Response to Information Request

Development Application for Material Change of Use – Multiple Dwelling (4 Units)

65 Stagpole Street, West End and formally identified as Lot 3 on SP338397

Information Request

Client T & R AKINYEMI	
Project Details MULTI-RESIDENTIAL DEVELOPMENT 65 STAGPOLE STREET WEST END QLD 4810	
Drawing Title VEHICLE TURNING PATH SITE ENTRANCE	
Job No. STP24-1965	Drawing No. SKC-100
Revision A	Date 13.07.26
CIVIL

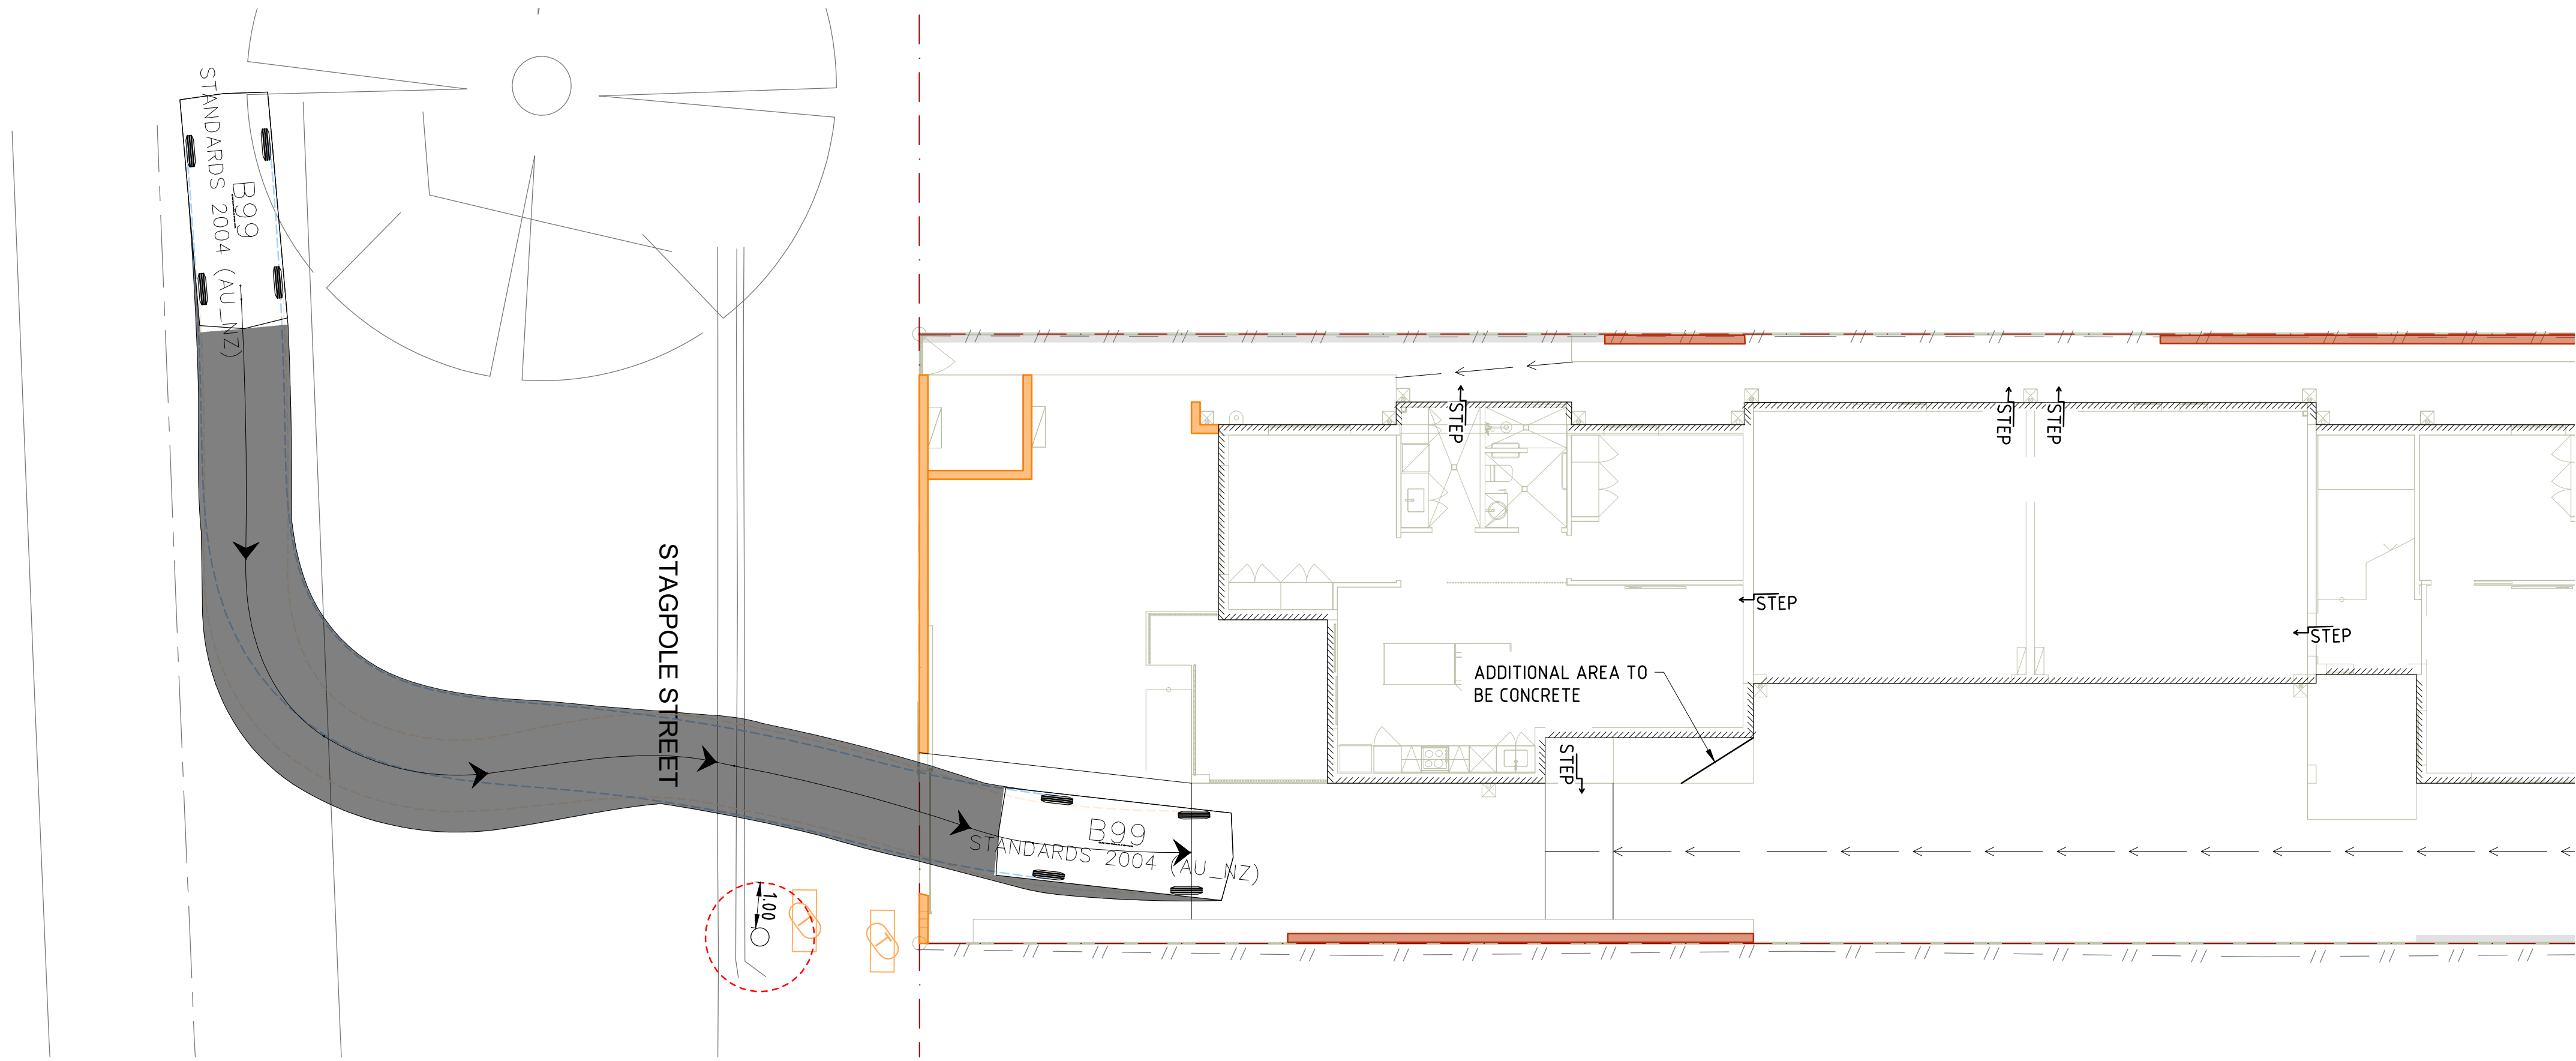
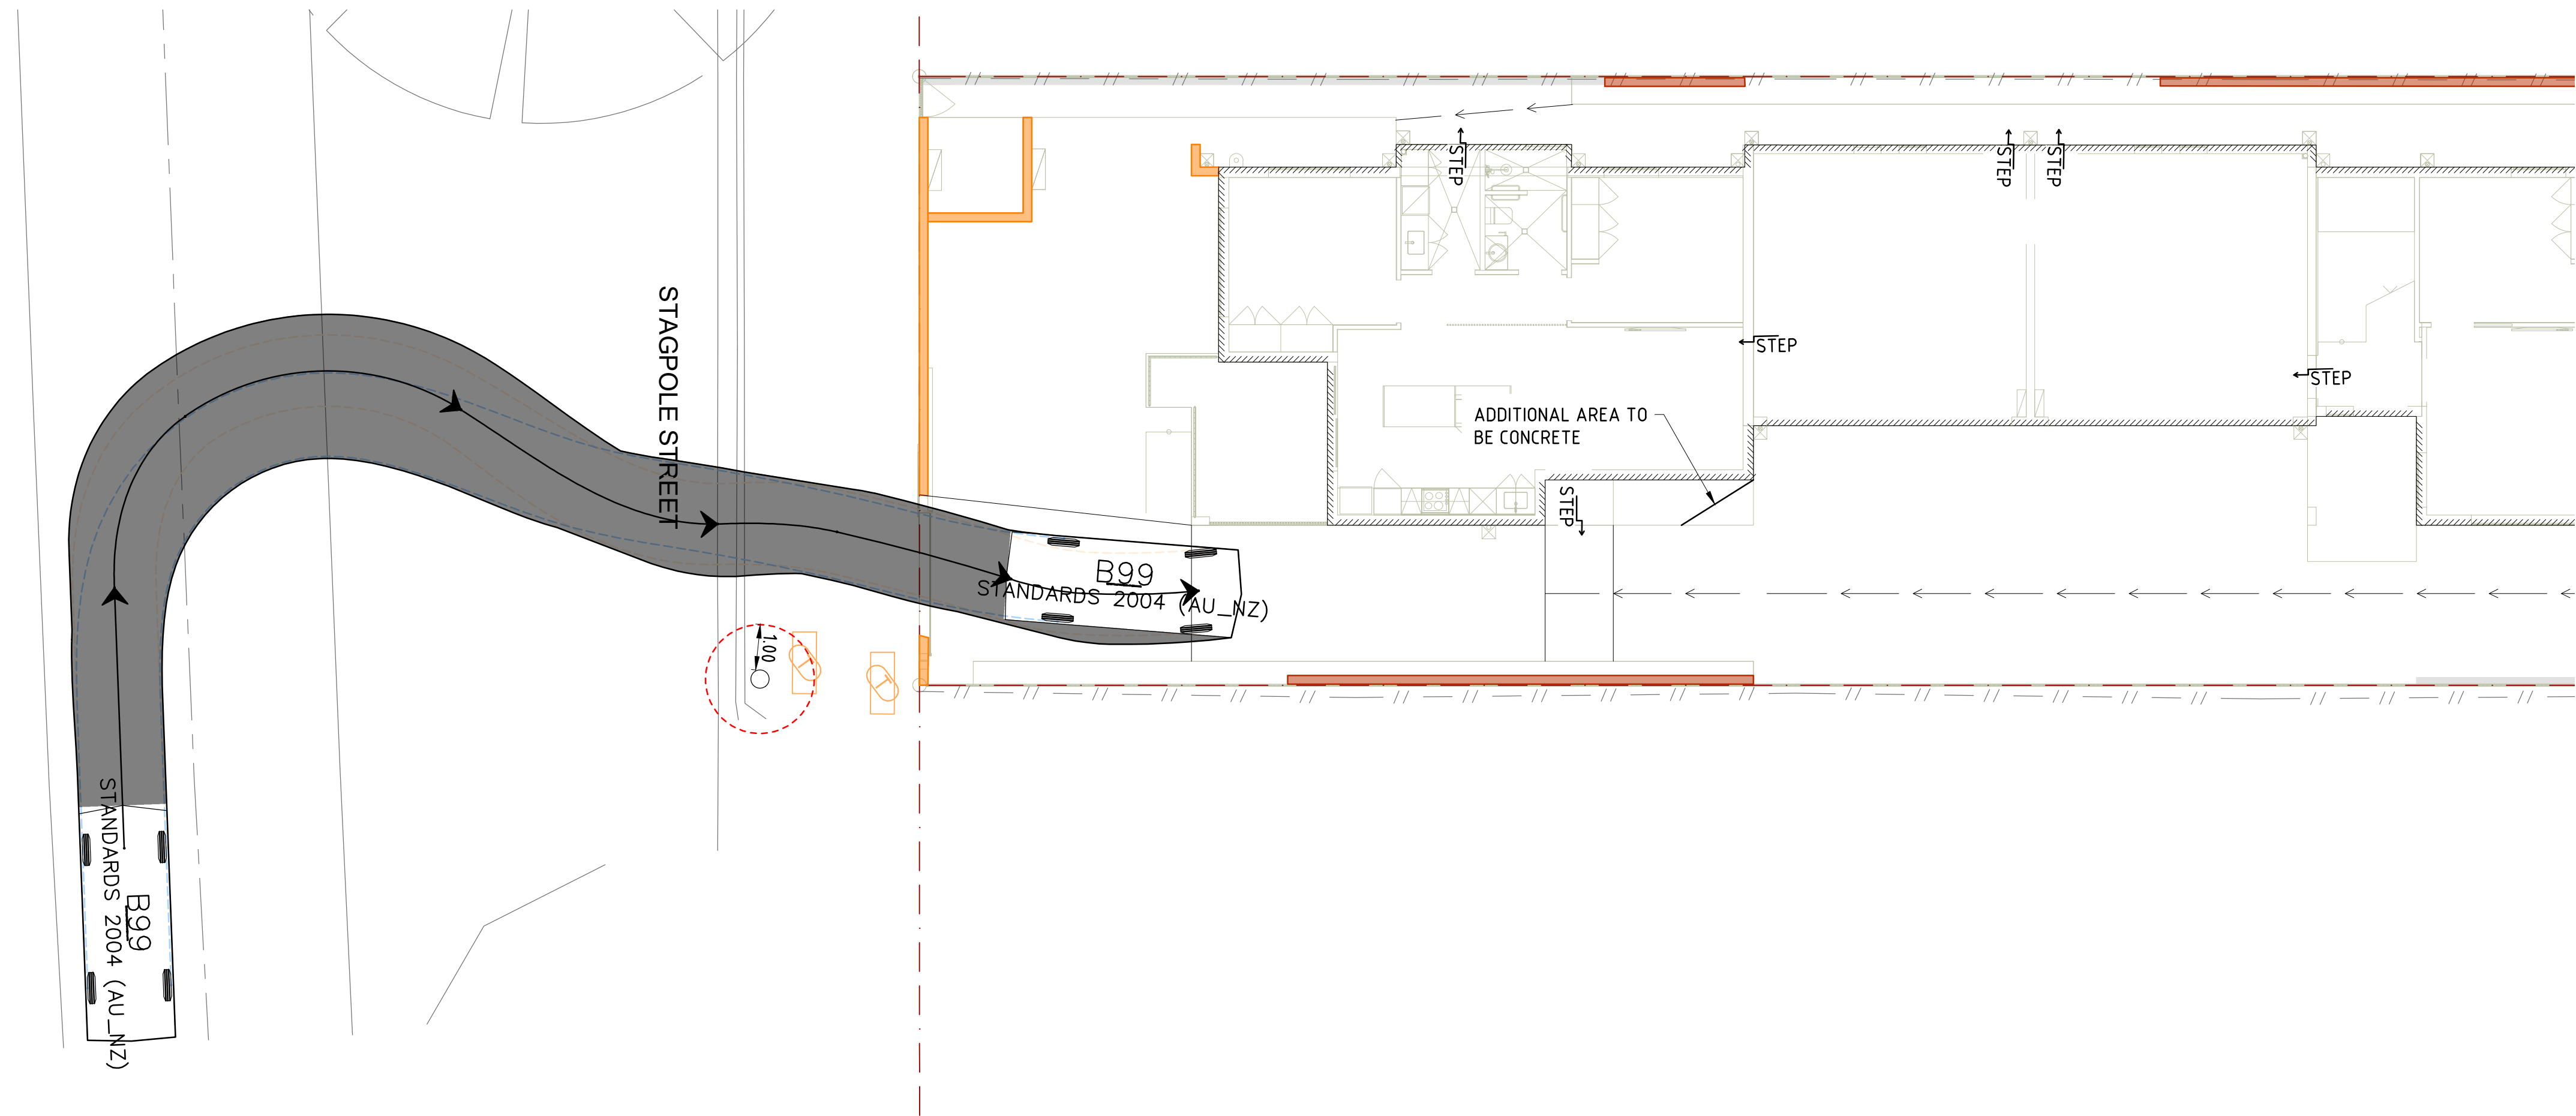
The applicant is requested to provide vehicle movement swept paths from a qualified RPEQ demonstrating vehicles can safely and conveniently manoeuvre to/from the site as well as internally manoeuvre to/from the onsite carparking spaces.

In response to this item, please find vehicle swept path plans prepared by STP Consultants at **Attachment 3**. It is considered the provided plans suitably demonstrate that passenger vehicles can efficiently and safely enter and exit the site and manoeuvre within the proposed internal carparking areas.
